Studebaker

SERVICE BULLETIN

NO. 260

1952

FIG. 1

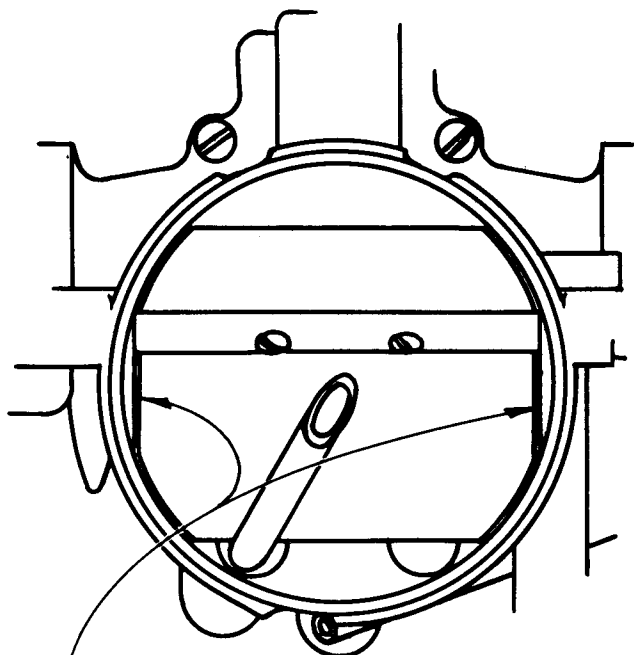
On some of the early Stromberg AAUVB-26 carburetors stamped with Code 6-111, used on 1951 (H) Commander models, there was an interference between the air horn body and the carburetor choke valve. This condition becomes noticeable usually in extremely cold weather due to abnormal contraction of the body. The interference may be at either side of the choke valve near the part that is attached to the shaft.

FILE THESE SIDES AS REQUIRED
TO PROVIDE CLEARANCE

In most cases the interference can be relieved by loosening the two choke valve-to-shaft attaching screws and shifting the valve away from the housing sufficiently to allow it to move freely. In a few cases it may be necessary to remove the valve and carefully file a few thousandths of an inch from the flat surface on either side of the valve. See Fig. 1.

FIG. 7

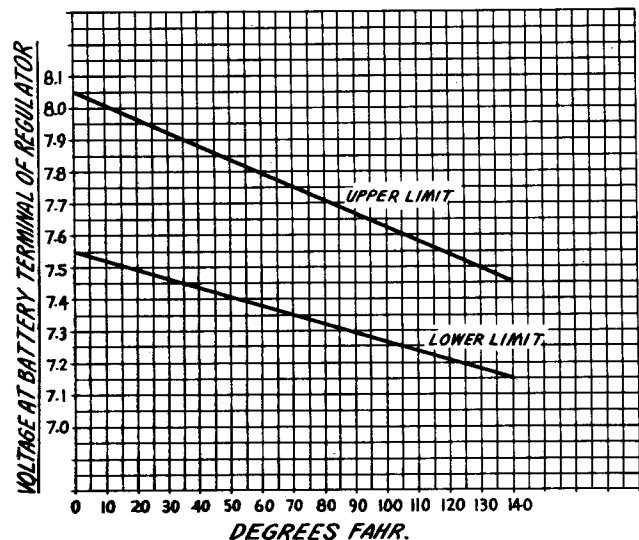
The accompanying chart (Fig. 7) supersedes that shown on page 12 of the 1952 Supplement to the 1951 Passenger Car Shop Manual. This chart shows the latest test curve limits for the voltage at the battery terminal of the Delco-Remy regulators Model No. 1118392 (used on 1951 Commander V-8 passenger cars and 2R Series trucks with 245.6 cu. in. engine and 40 amp. generator) and Model No. 1118730 (used on 1952 Commander V-8 passenger cars and 2R Series trucks with 245.6 cu. in. engine and 45 amp. generator).

It will be noted that both the high and low limit curves throughout the temperature range on this chart are .15 volts above the respective high and low limit curves previously published.

FIG. 11

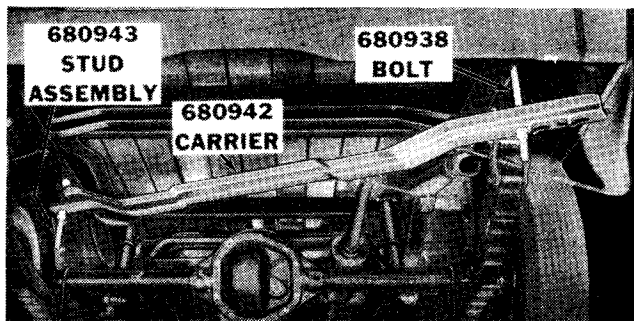
The new type carrier can be installed on 2R Series trucks manufactured before the above serial numbers by drilling the frame side members as indicated in Fig.10 and using the parts shown in the list at the end of this article. Fig.11 shows the complete installation.

On the 2R10 and 2R11 it will be necessary to move the upper wheel carrier support back of the frame crossmember as shown in drawing.

This is required because the tail pipe used before the above serial numbers would interfere with the new carrier. The new tail pipe can be used with either the old or new type carriers without interference.

FIG. 12

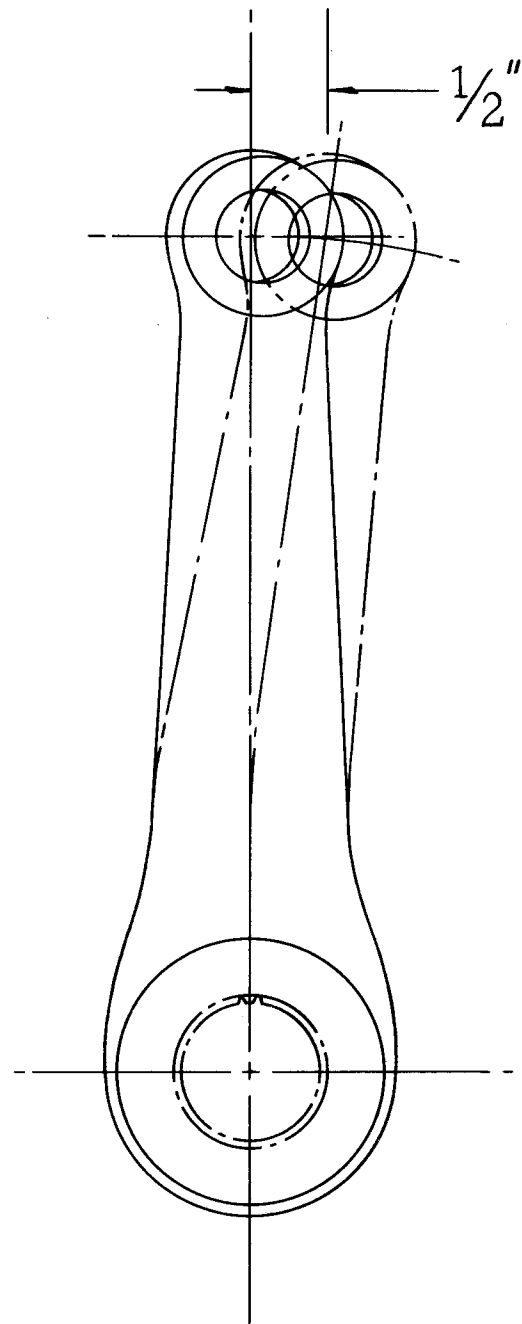
Shortly after the Saginaw steering gear entered production it was found that in some cases the steering gear would not be in the center position when the front wheels were in a straight ahead position. It is impossible to move the steering arm one serration to correct the condition because of a block or wide tooth which allows the arm to be placed on the cross

To overcome this situation, it was decided to bend the arm 5° as shown in Fig. 12. The bent arm entered production with Serial Nos. R5-87708, R6-5051, R10-32648, and R11-4351. Service stock steering arms, Part No. 680651, will have the contour shown and to correct inability to center the steering with the wheels in the straight ahead position, the bent arm should be installed.

FIG. 15

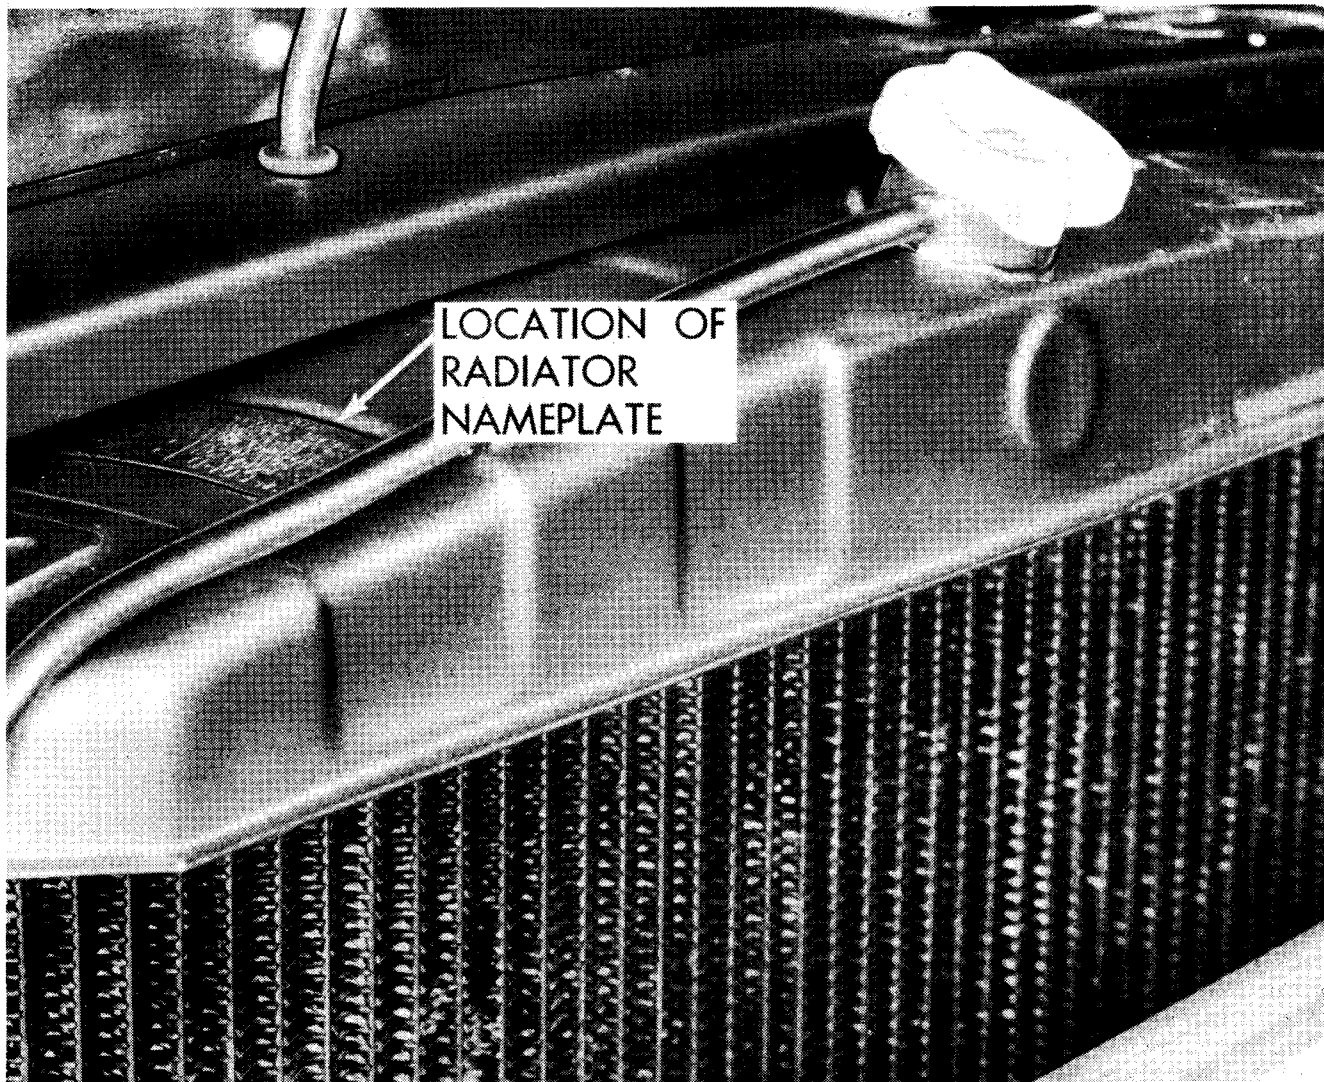
A nameplate, giving radiator core serial number, is now placed on the top of the core (above) on either side of 2R Series Trucks equipped with 245.6 cu. in. engines effective with the following Serial Nos.: R6-5838, R11-4981, R14-876, R16A-37263, and R17A-27743.
